HISTORIC AND DESIGN REVIEW COMMISSION

September 06, 2017

HDRC CASE NO: 2017-454
ADDRESS: 529 DEVINE ST
LEGAL DESCRIPTION: NCB 2957 BLK 1 LOT 19
ZONING: R-5, H
CITY COUNCIL DIST.: 1
DISTRICT: Lavaca Historic District
APPLICANT: Wade Lewis
OWNER: Wade Lewis
TYPE OF WORK: Window replacement

Exhibit
B.

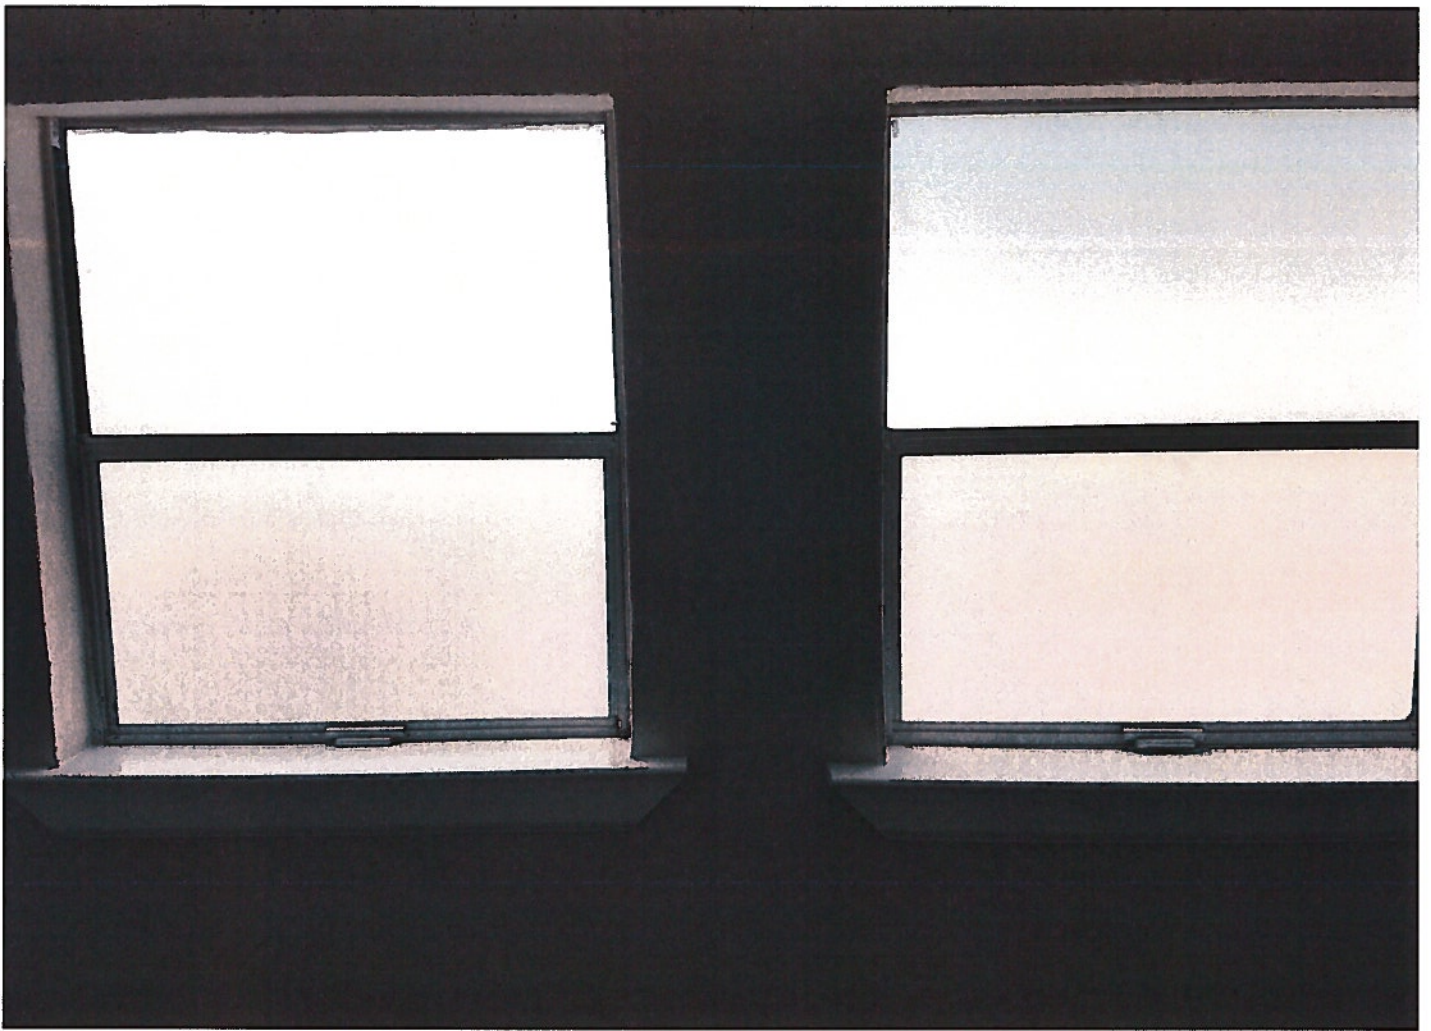
Window #3

To be replaced with vinyl window

window #4

Rotted siding to be replaced with like siding - 117 SYP Board

Staff does not recommend approval of item #1, the replacement of wood windows. Staff recommends that all existing wood windows be repaired and that the removed sashes be repaired and reinstalled in the house.

Staff recommends approval of item #2, the replacement of aluminum windows, with the stipulation that the profile of the proposed vinyl windows match that of the historic structure's original wood windows and feature a framing depth that is consistent with the historic windows.
